**Re: Sovereign at Shipyard – Response to Boswell Underwater Engineering Draft Report
Hoboken, NJ**

We are writing this letter in response to the draft report written by Boswell Underwater Engineering (Boswell) on the underwater survey they performed of the Hoboken Privately-Owned Waterfront Structures (dated March 2011). Specifically, we are responding to the comments made regarding The Sovereign at Shipyard building (reference section 6 of the report).

Drawing Title:
TYPICAL DETAILS
 Scale: AS NOTED
 Date: May 07, 2004
 II. U. B. Sheet No.
 Drawing No.: **S002**

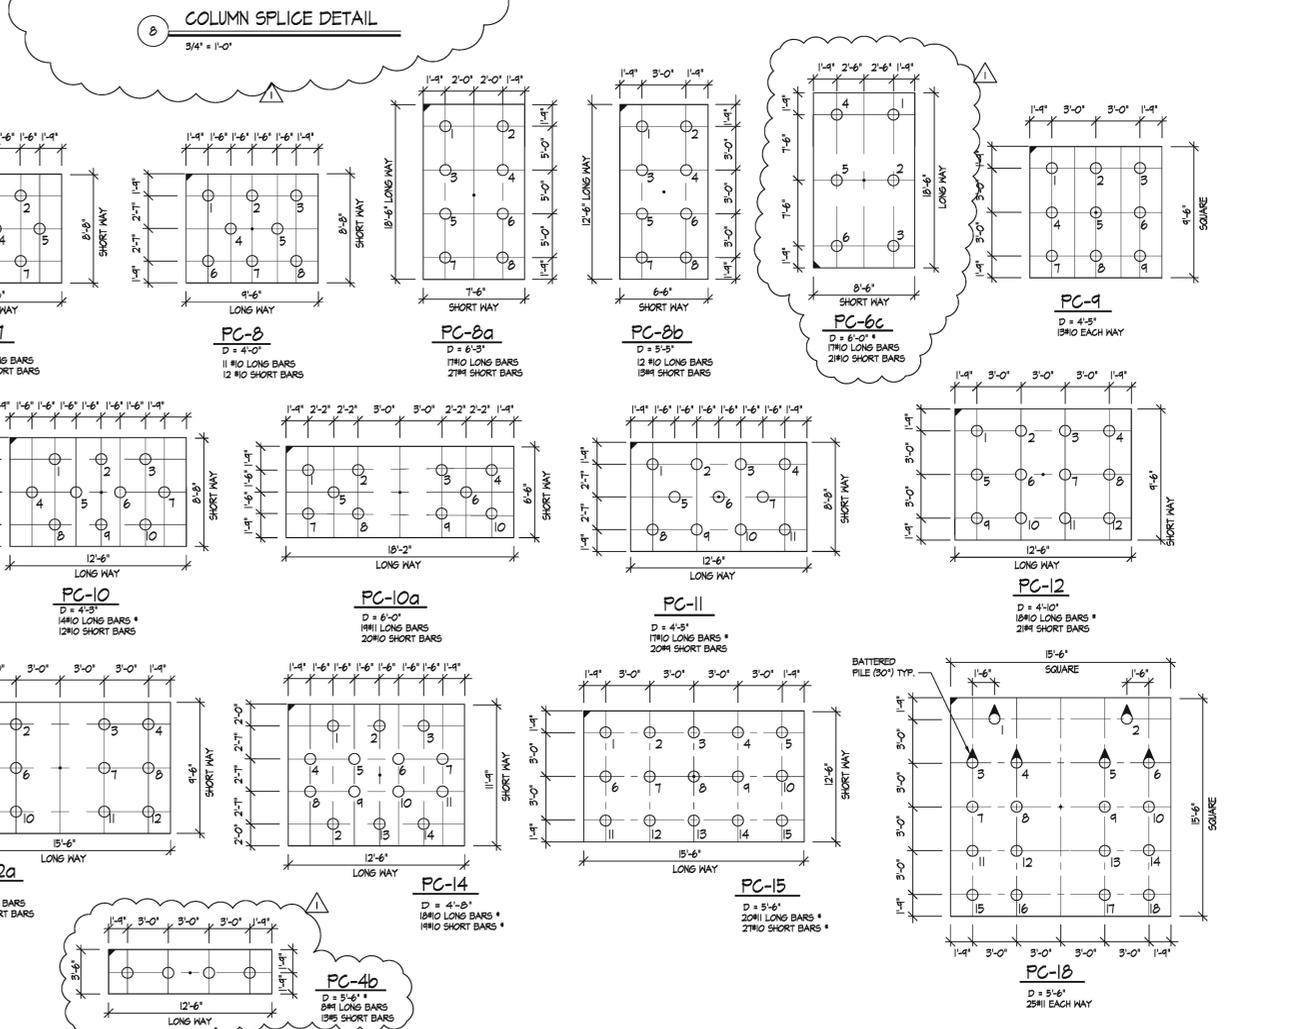
This section states that some loss of protective coating and minor to moderate corrosion was found at the steel pipe piles within the tidal zone. Based on testing conducted, the writer estimates an average section loss of the pile cross section of approximately 14%.

The building structure was designed to be supported on 100 ton piles. The piles supporting the portion of the building over the river were reinforced so as not to require the steel casing (pipe) in order to carry the building loads (reference Foundation Notes on drawing S-001 and section 13 on

drawing S-002, attached). The piles in this area (north-east corner of the building) were designed in anticipation of the section of the pipe above the river mud line corroding away over time, which is consistent with the conditions depicted in photographs 6.11 and 6.12 of Boswell's report. The concrete filled pipes were reinforced with epoxy coated reinforcing steel so as to be maintenance free in the long term.

S100

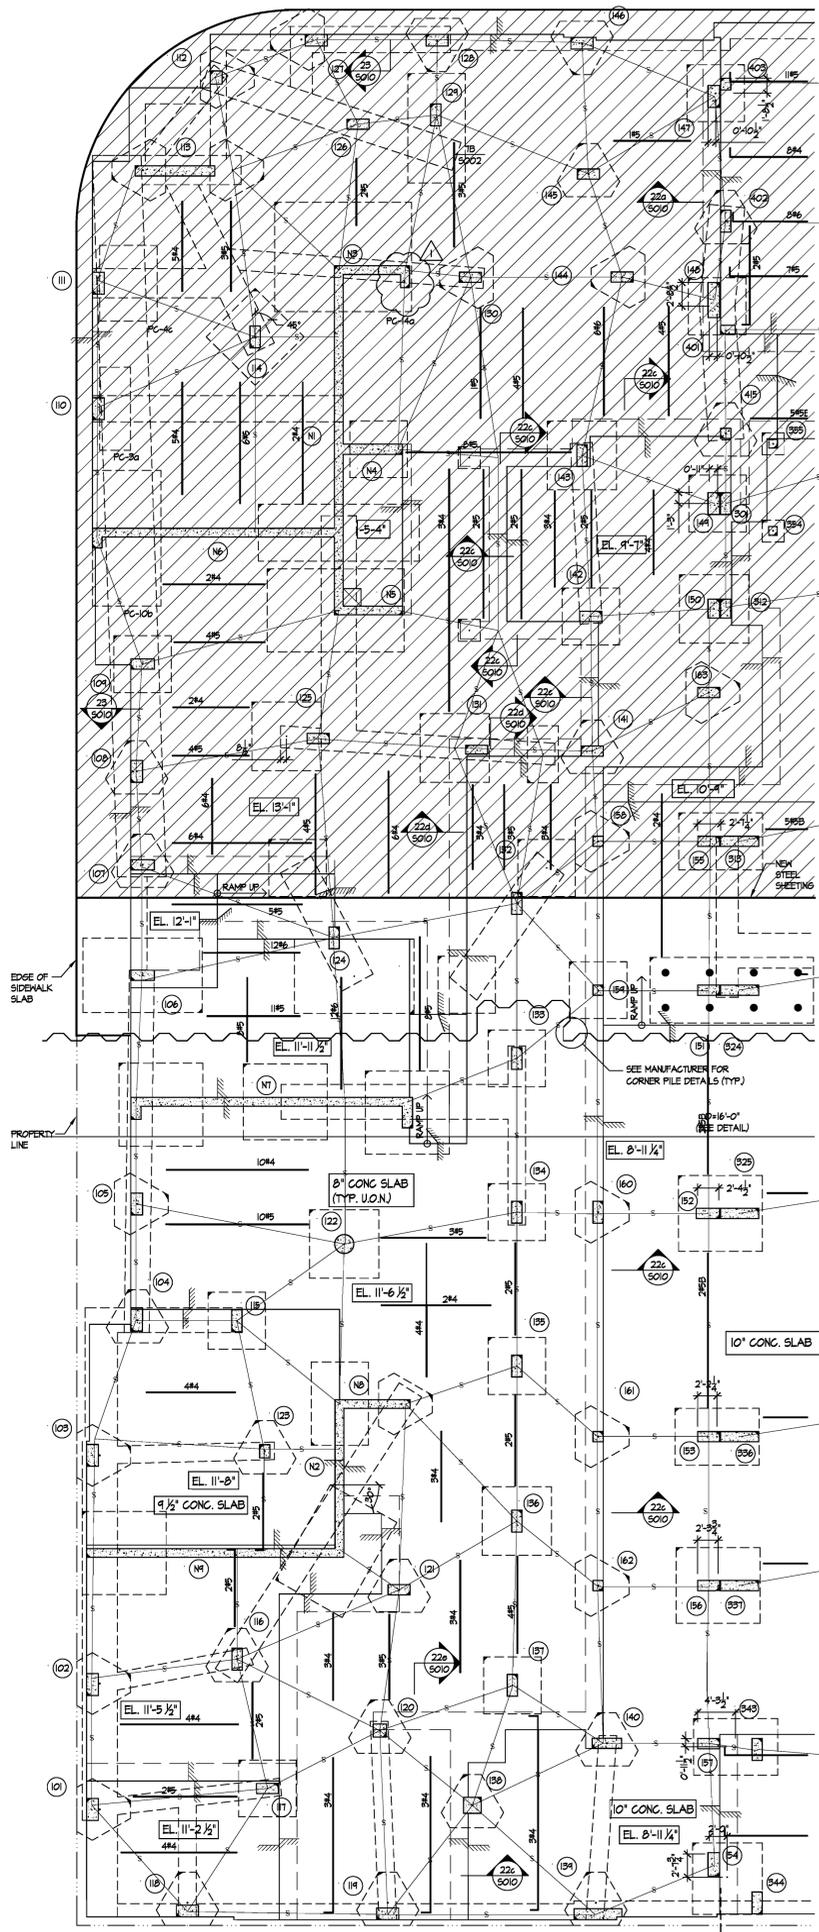
This section states that no apparent bulkhead to retain the inland fill was visible and that the tidal waters have allowed fill to escape and settle below the structural slab of the Sovereign building.

Pictures 6.11 through 6.15 in Boswell’s report depict settlement of the fill above the existing platform (below the building structural slab) as well as rigid insulation delaminating from the underside of the slab. The condition revealed in these photographs does not, however, raise any structural concerns. The ground floor slab of the Sovereign building is a reinforced concrete slab which was designed to span between pile caps (reference drawings S-101 and S-301, attached). The insulation served simply as formwork to support the wet concrete when the slab was poured. Structurally this slab behaves just as the upper floor slabs do in as much as the formwork is only required until the concrete has cured sufficiently to reach adequate strength to span between permanent supports.

No bulkhead wall was encountered at the north-east corner of the building during the inspection because it is located on the land side of the wood platform supporting the existing sea wall. A new bulkhead wall was installed in the form of corrugated steel sheet piles which were driven inland of the existing wood platform to retain the soil beneath the remainder of the building (reference plans on S-100 and S-300 and details 6, 7A, and 7B on drawing S-100, attached).
